Millstone Nuclear Power Station, Unit No. 3
Transmittal of Responses to Requests of Additional
Information and Draft SER Open Items (Geotechnical Issues)

RESPONSE OR SCHEDULE FOR
SUBMITTAL OF RESPONSE
TO GEOTECHNICAL MEETING ACTION ITEMS
(241 SERIES QUESTIONS)

SUBJECT: Meeting Summary - February 14, 1984
Discussion of 241 series Questions and
Draft SER Geotechnical Open Items

RESPONSE TO REQUESTS FOR
ADDITIONAL INFORMATION
ACTION ITEMS RESULTING FROM FEBRUARY 14th MEETING

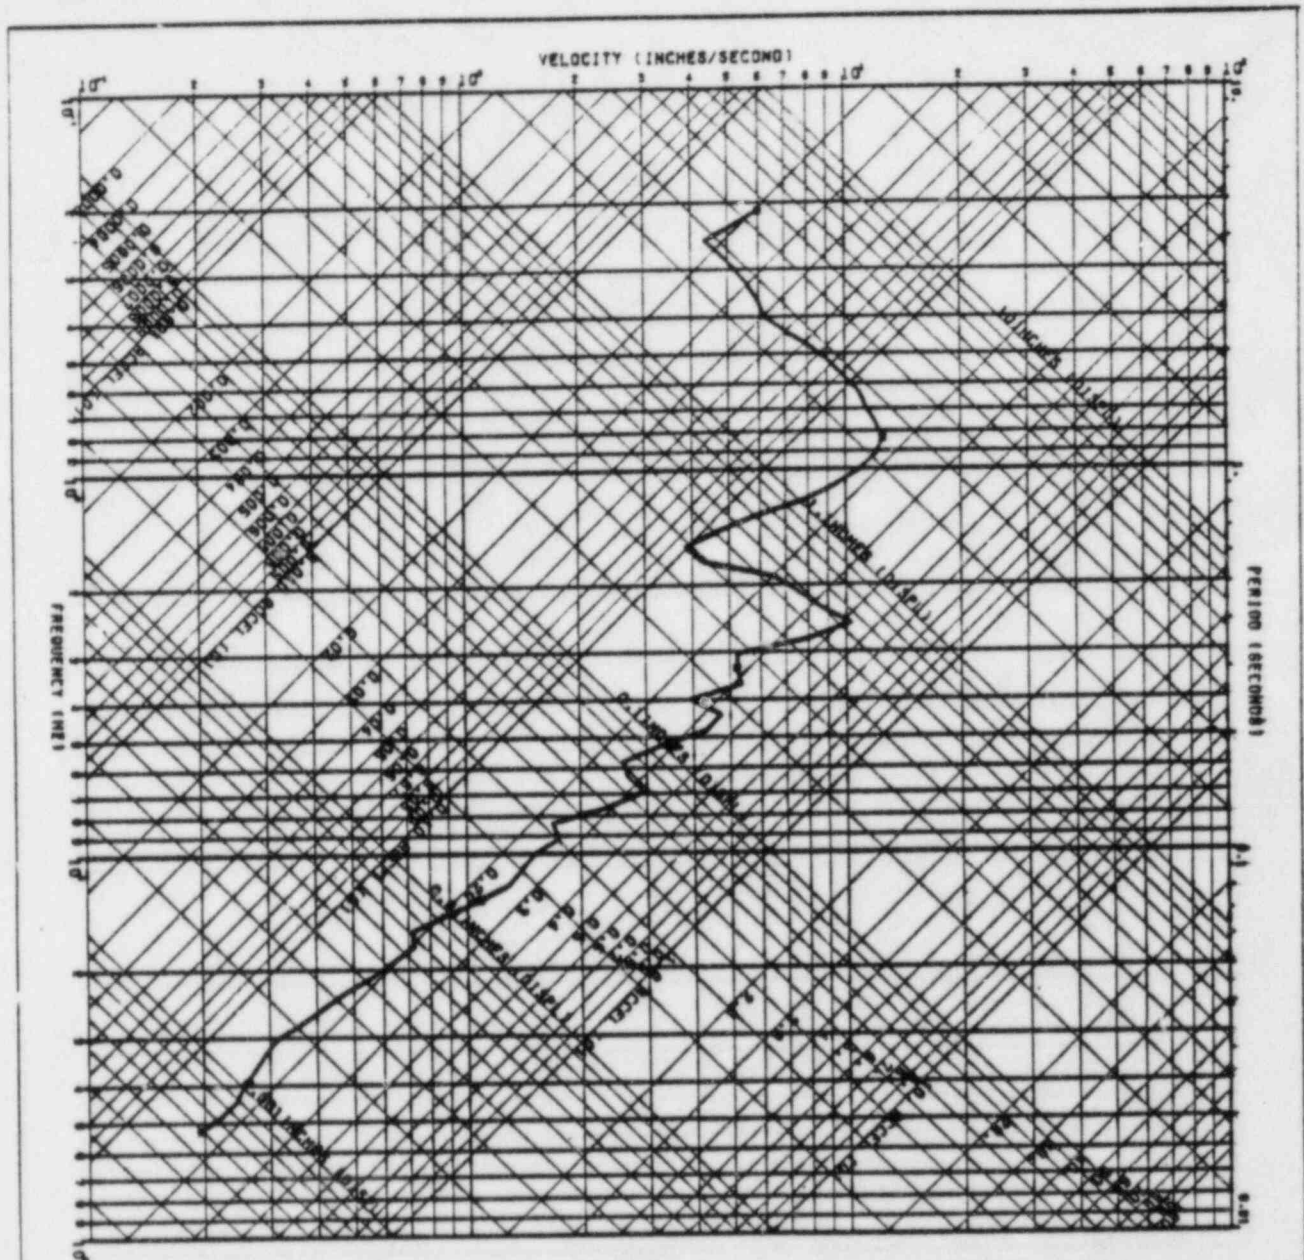
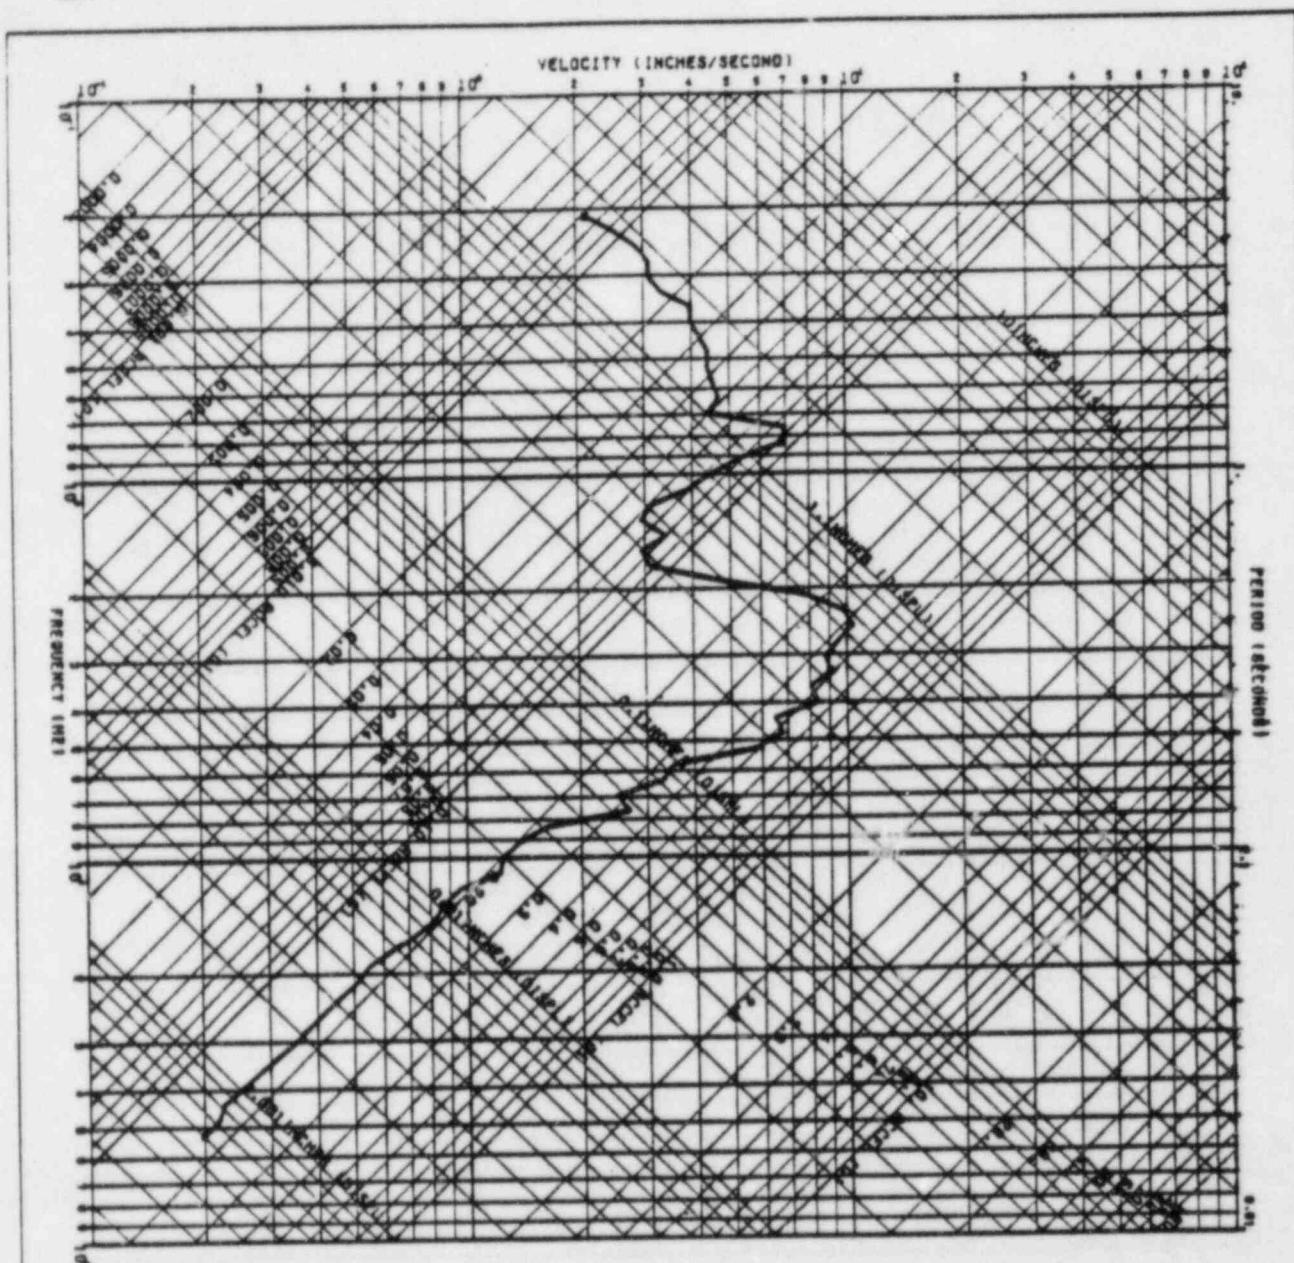
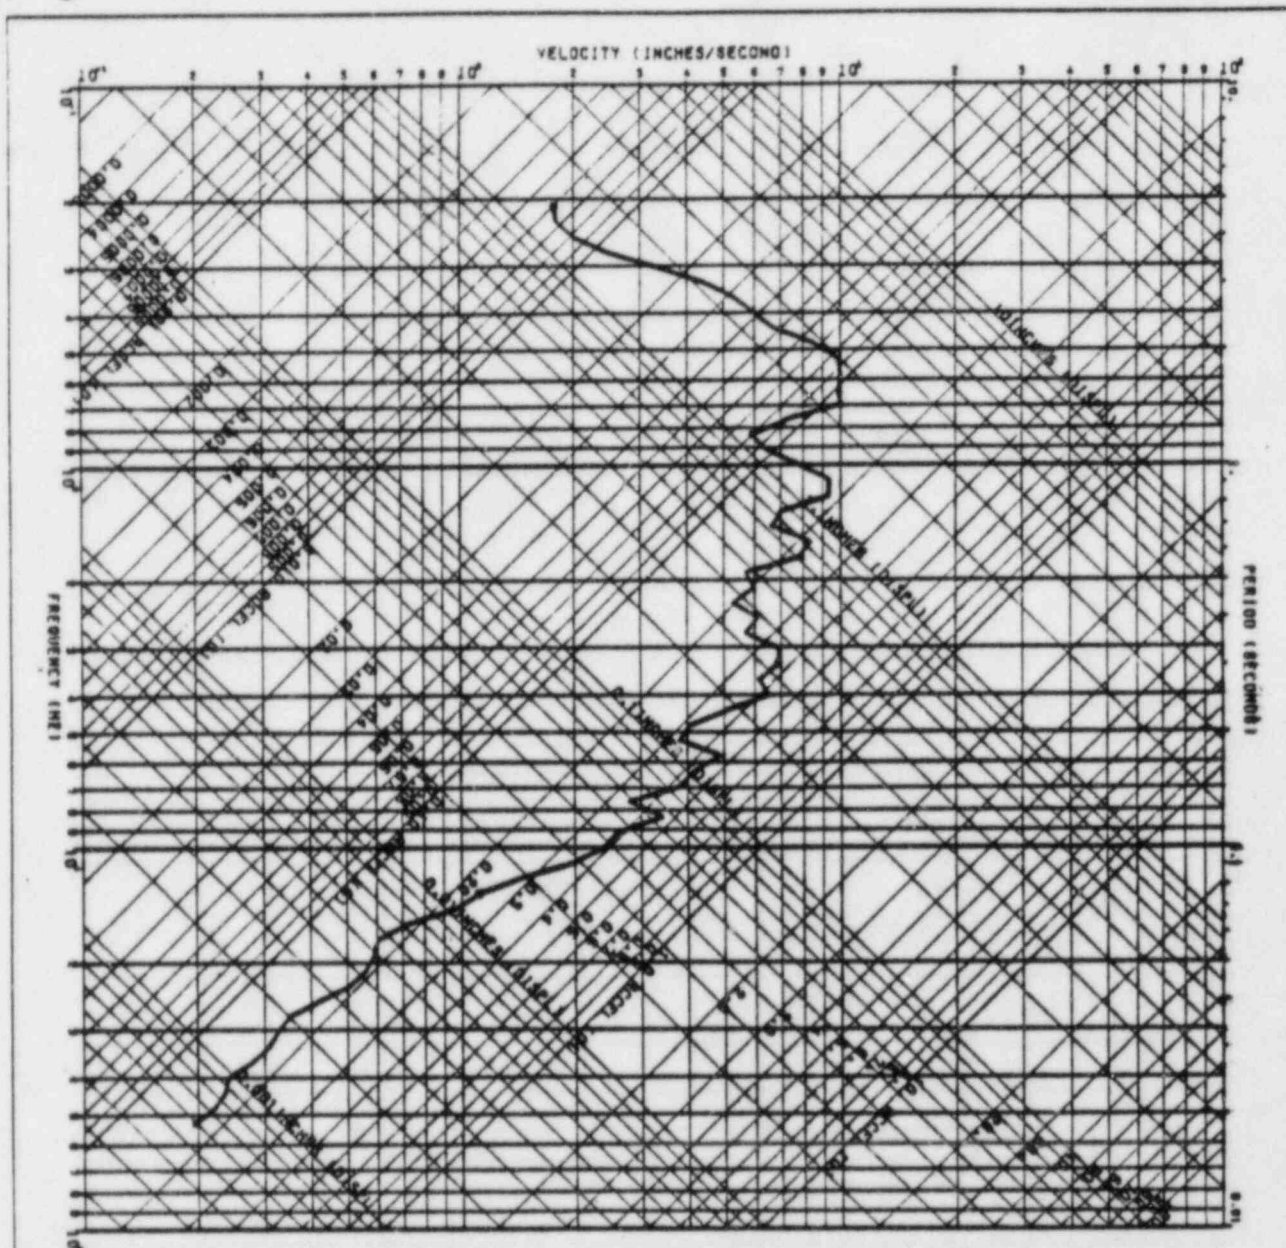
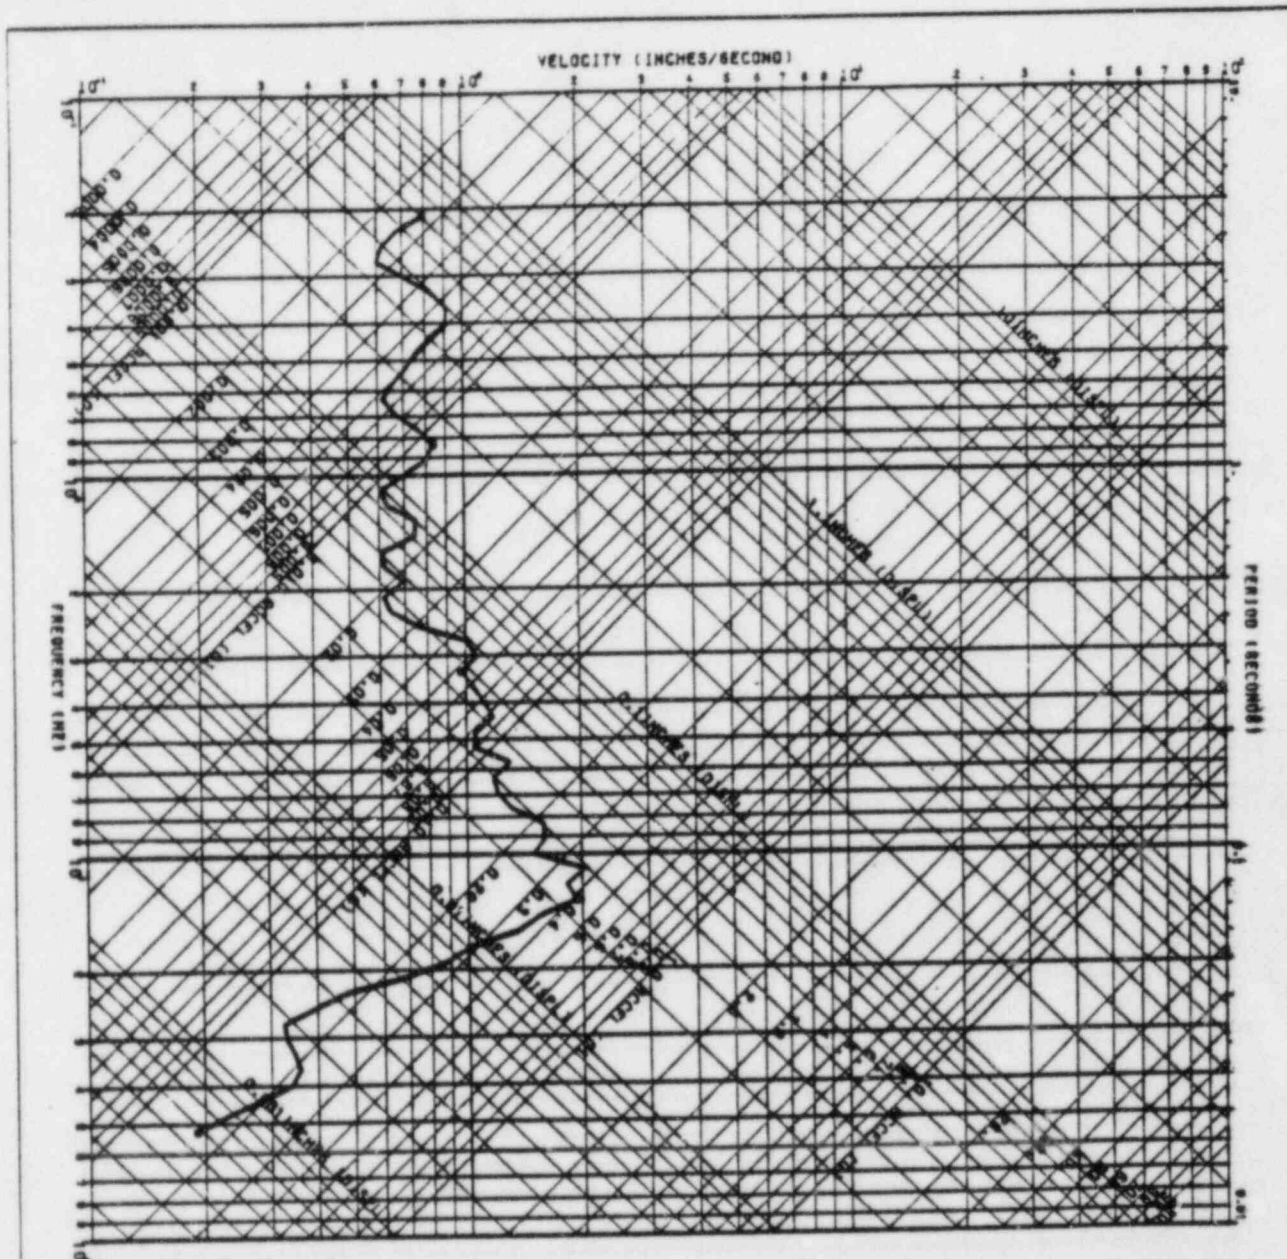
- c) Action: NUSCO will provide bedrock spectra for each time history used in the analyses.

The Response spectra for the beach area SHAKE Analysis have been provided.

FIGURE 2.5.5-6
POTENTIAL FAILURE WEDGES
WEST SIDE OF
CONTAINMENT EXCAVATION
MILLSTONE NUCLEAR POWER STATION
UNIT 3
FINAL SAFETY ANALYSIS REPORT

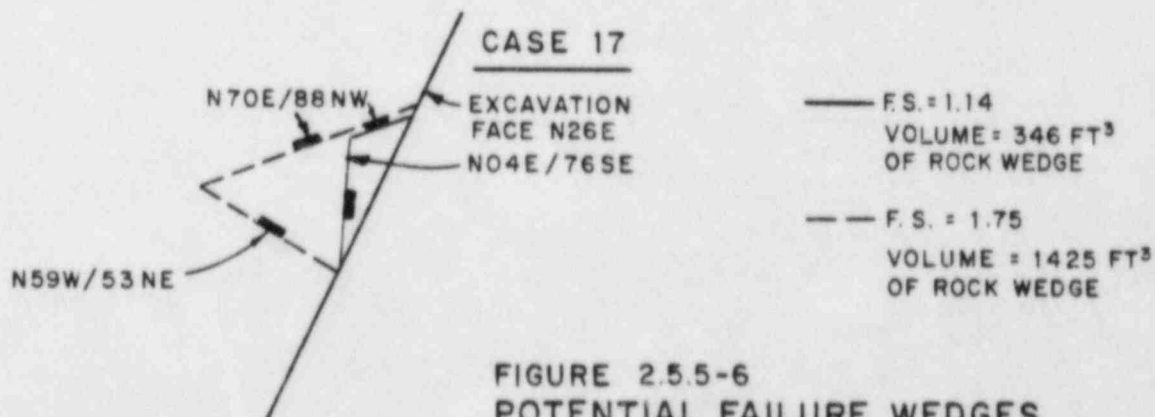
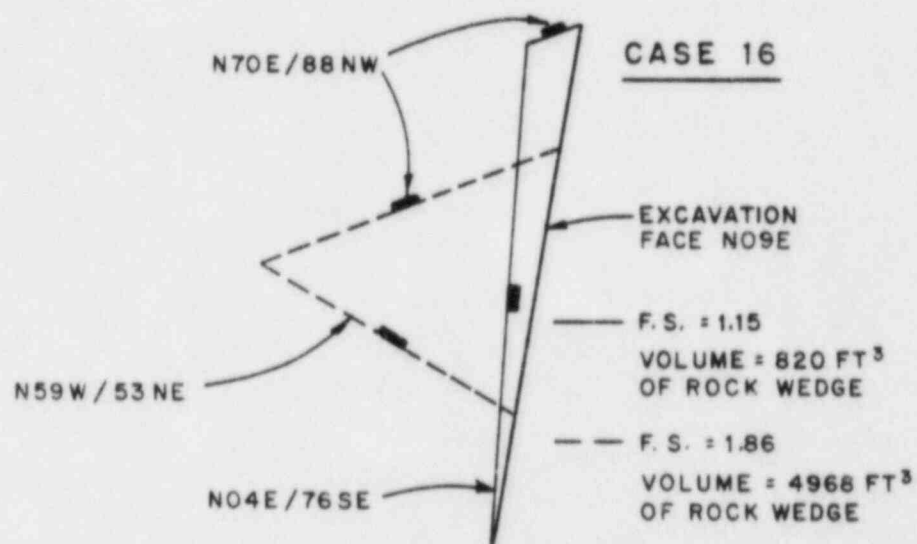
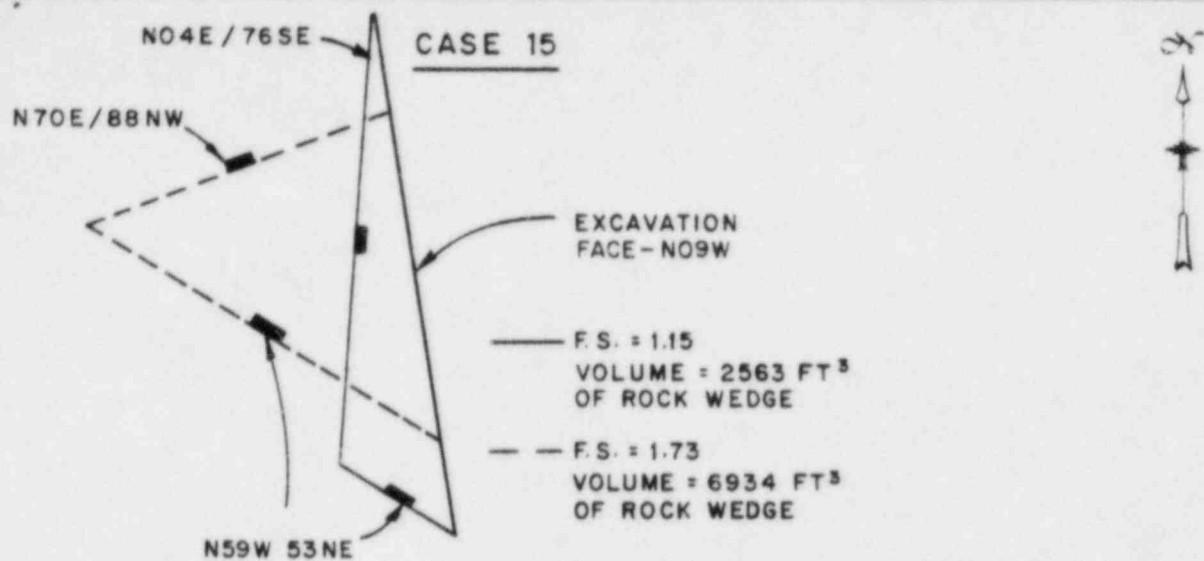
Action: We will provide a 2-dimensional plan with jointing and foliation for worst case (near Main Steam Valve Building). Also we will supply pictures of rock cut face and top view surface as requested by Mr. Chen.

Figure 2.5.5-b shows the Potential Failure Wedges for the West Side of the Containment. Figure 2.5.5-7 is a

Revised FSAR page 2.5.5-8 and Figures 2.5.5-6 and 2.5.5-7 in Amendment 8 to the FSAR provide the additional information requested by the NRC staff in Question 241.17 and Draft SER Section 2.5.5.2.

FIGURE 2.5.5-5
SUMMARY OF CIU TEST RESULTS-
BEACH AREA OUTWASH SANDS
MILLSTONE NUCLEAR POWER STATION
UNIT 3
FINAL SAFETY ANALYSIS REPORT

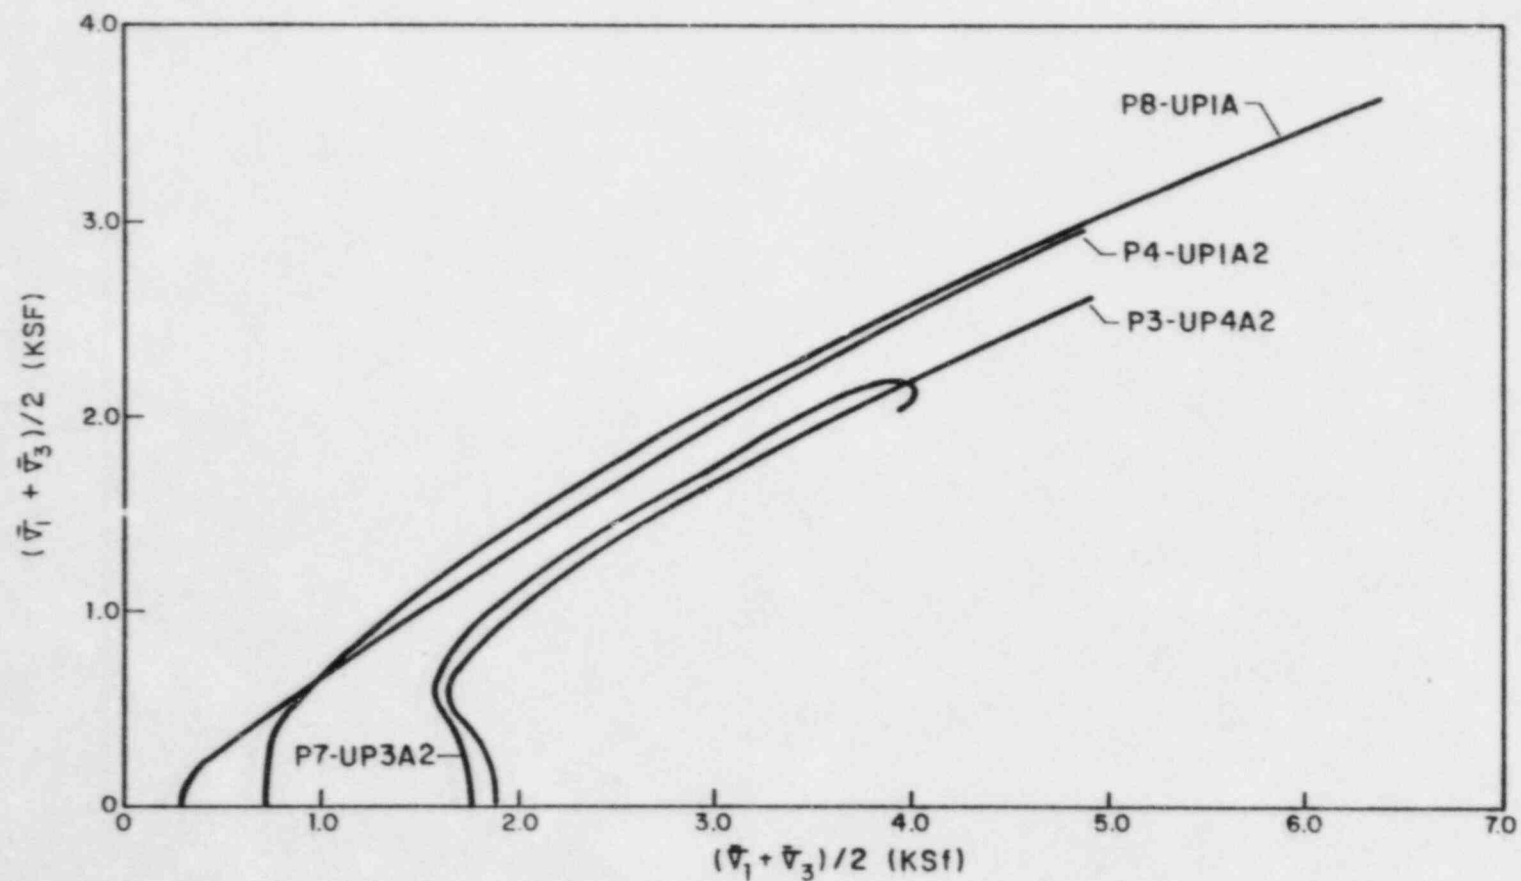
- a) Mr. Chen questioned the use of $\phi = 34^\circ$ for the beach sand, however, agreed that this is not a problem if liquefaction is okay.

Pages 2.5.5-5 through -7 of the FSAR have been revised to address Mr. Chen's concerns. Figure 2.5.5-5 provides a summary of the CIU test results for the beach area outwash sands.

FIGURE Q241.22-1
WEST RETAINING WALL
MILLSTONE NUCLEAR POWER STATION
UNIT 3
FINAL SAFETY ANALYSIS REPORT

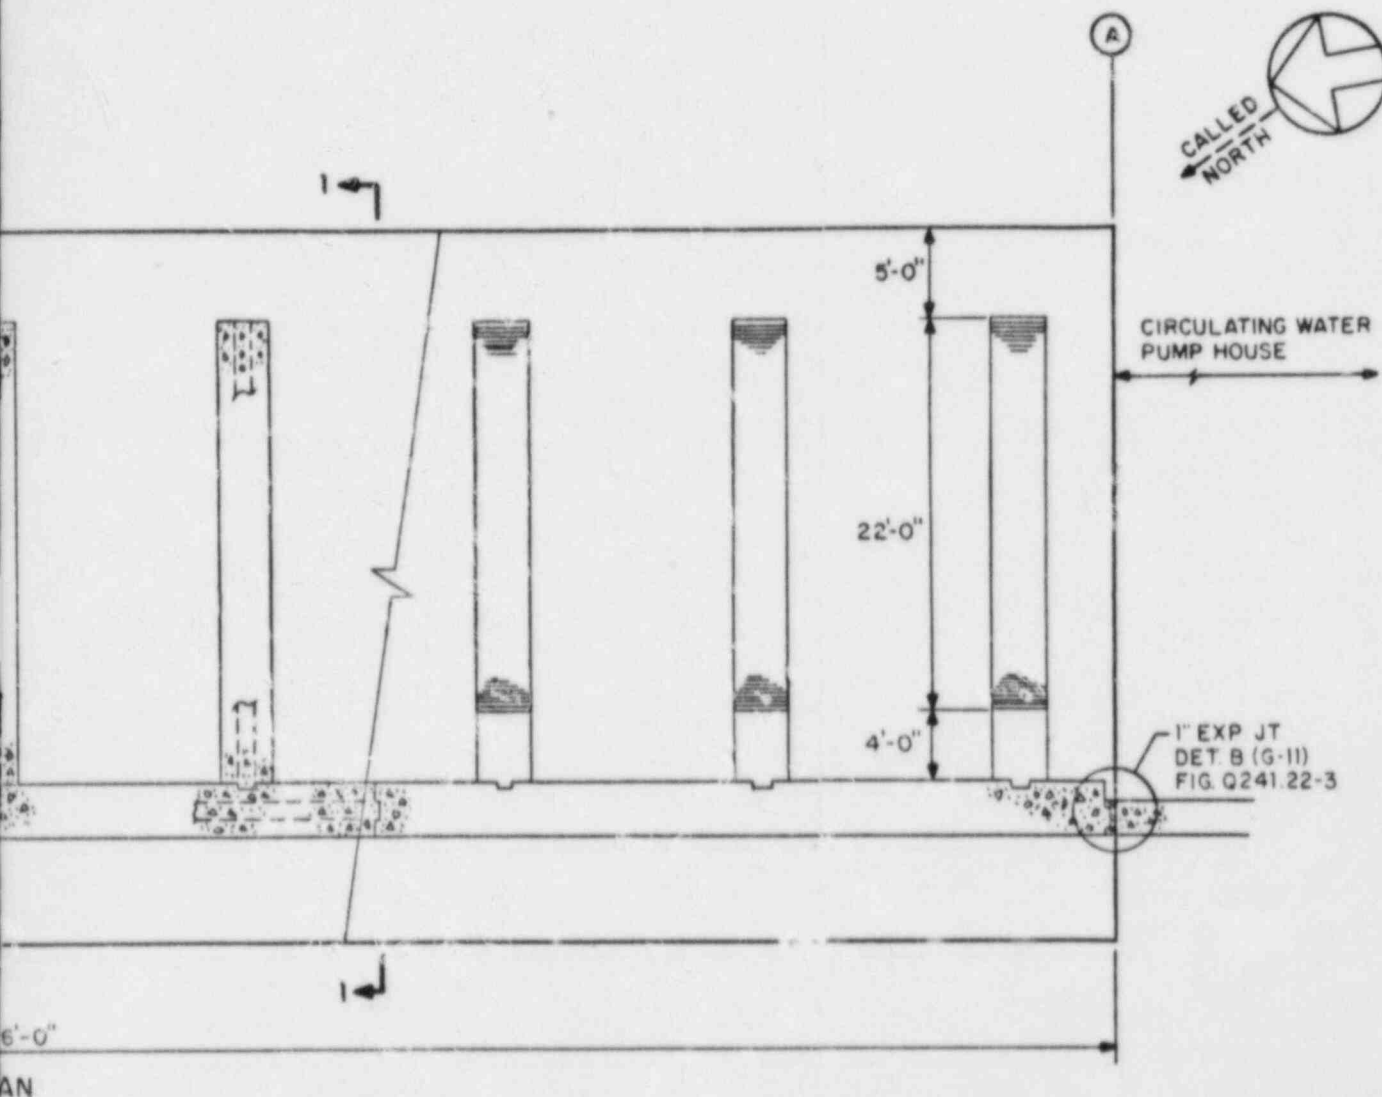
- b) Mr. Chen would like to see sections and plans of retaining¹ wall (Cat. I).

Action: We will provide this information.

Figure Q241.22-1 provides a plan view of the west retaining wall. Figures Q241.22-2 and -3 provide sections of the west retaining wall.
